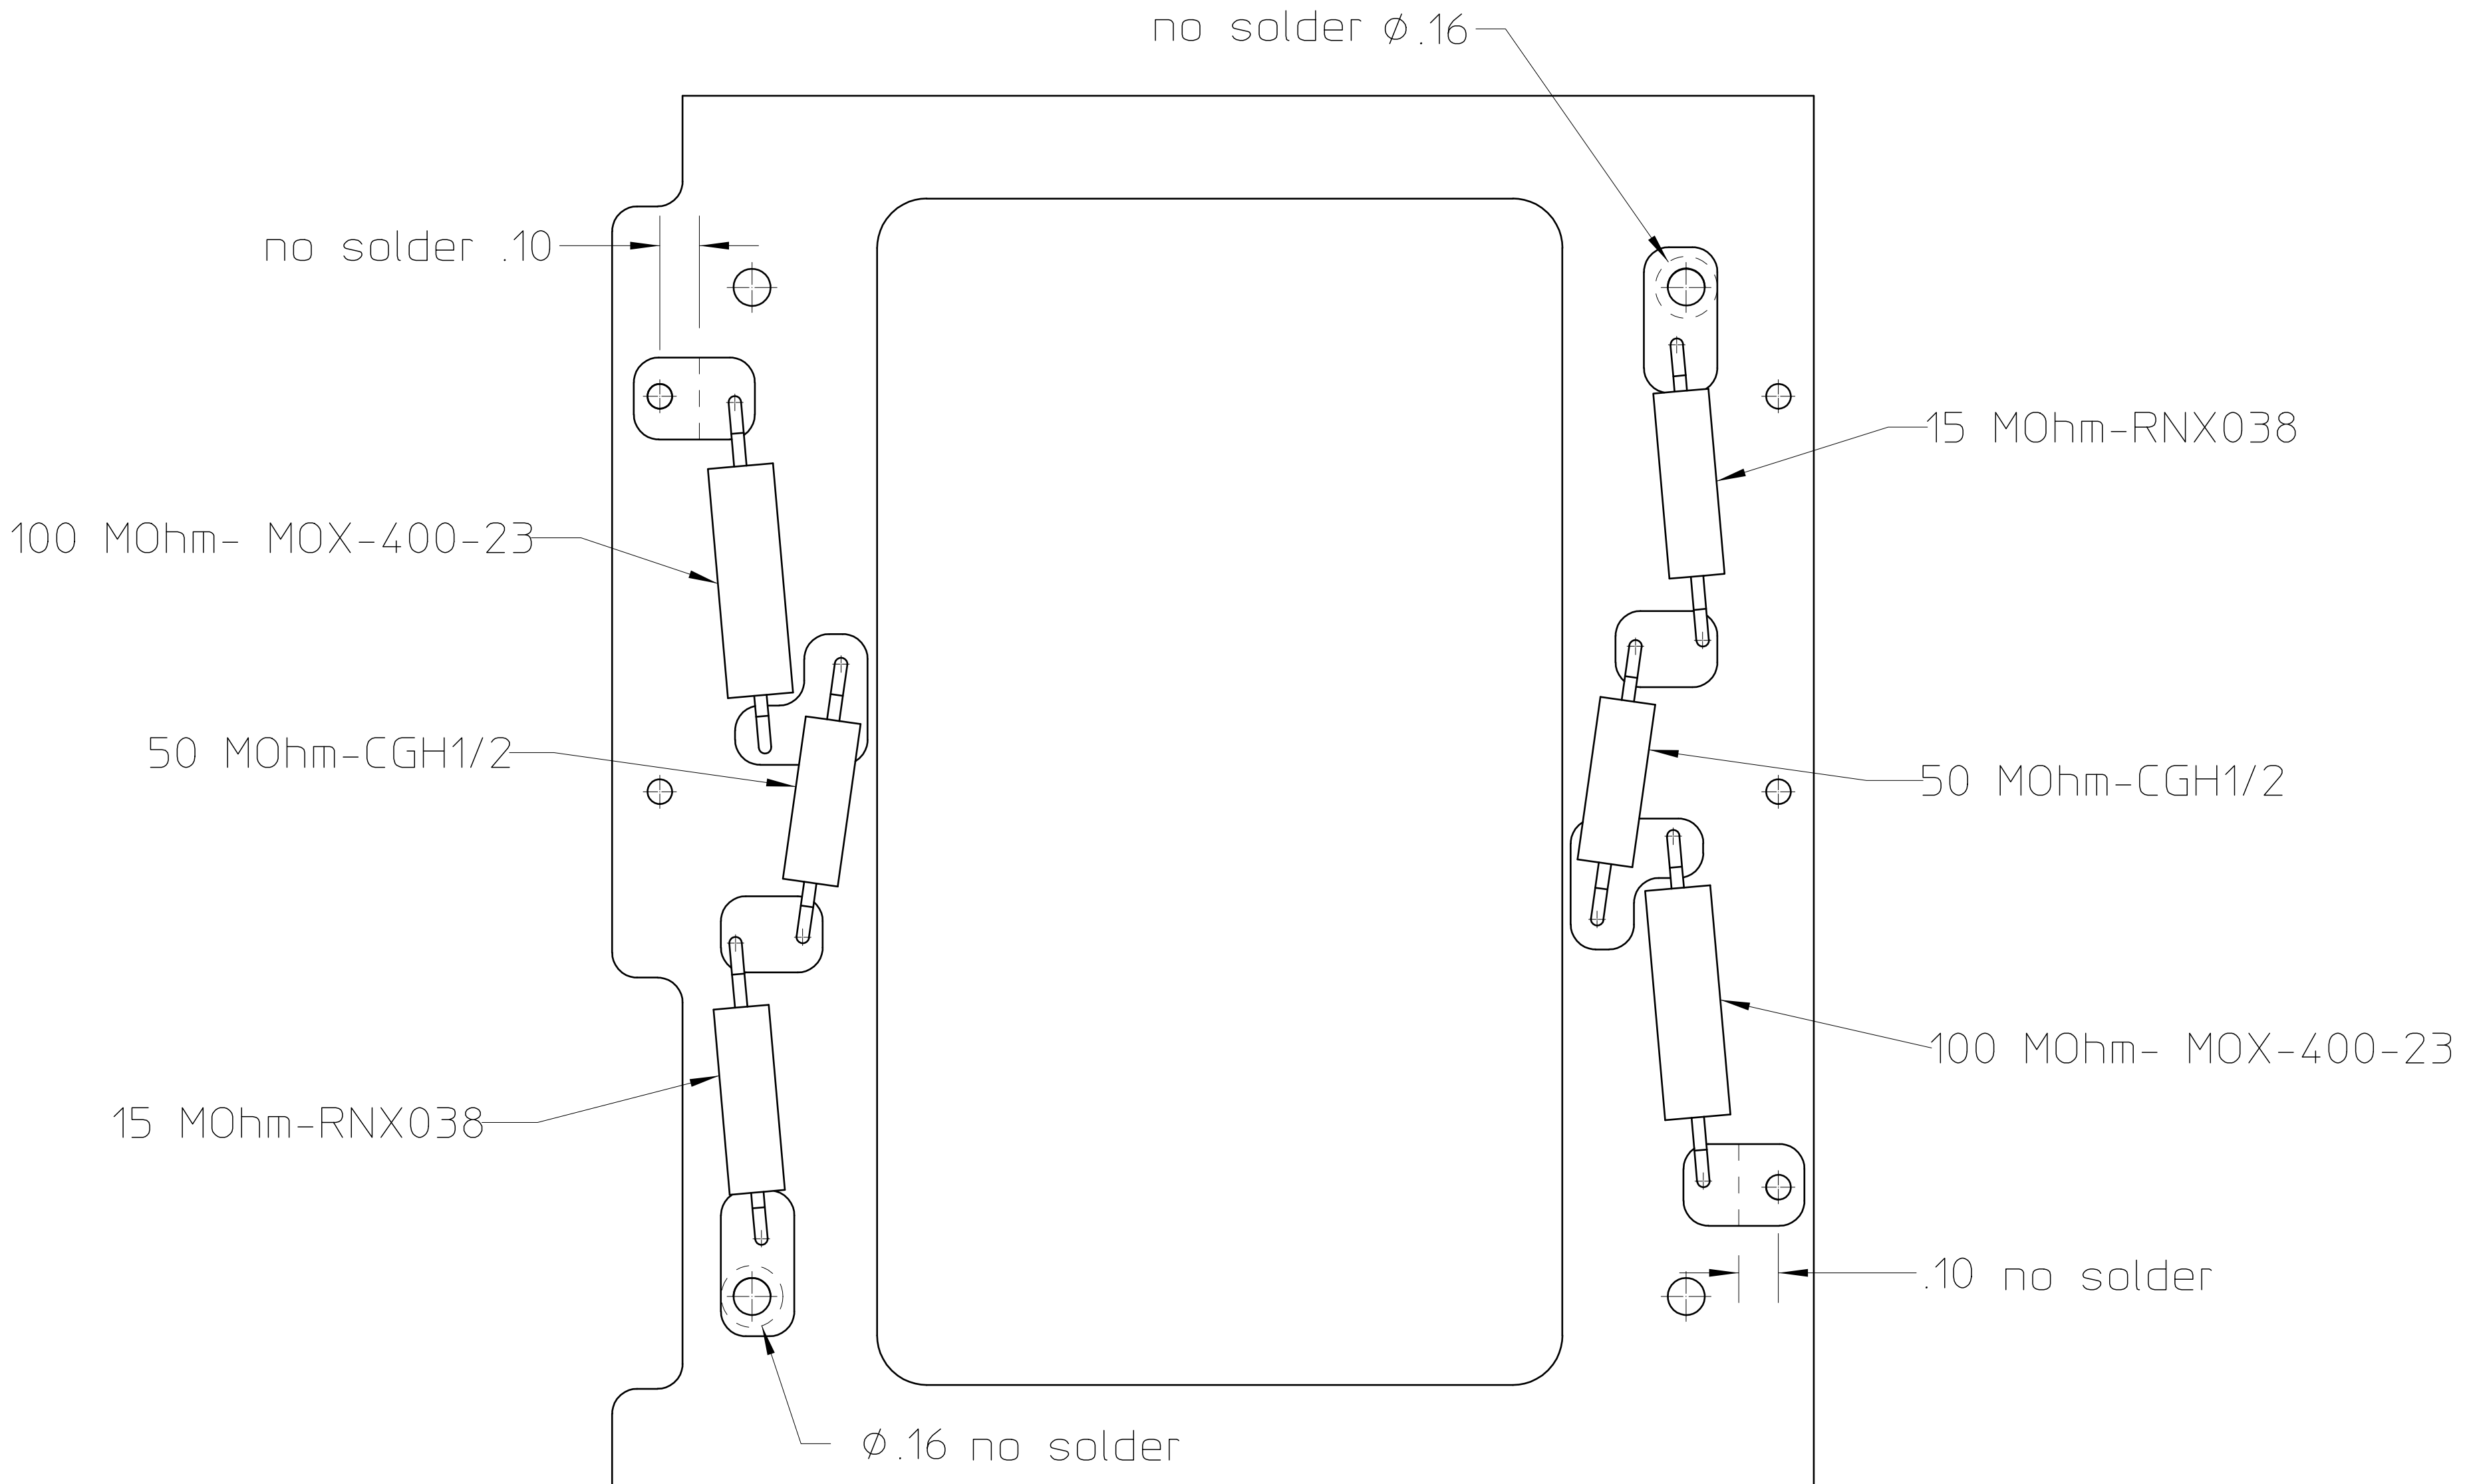
LEADS TO HAVE FLAT SECTION ADDED (.1"/.2" LG.) FOR PAD CONTACT
BEND LEADS CLOSER TO RESISTOR BODY TO PROVIDE FLAT SECTION
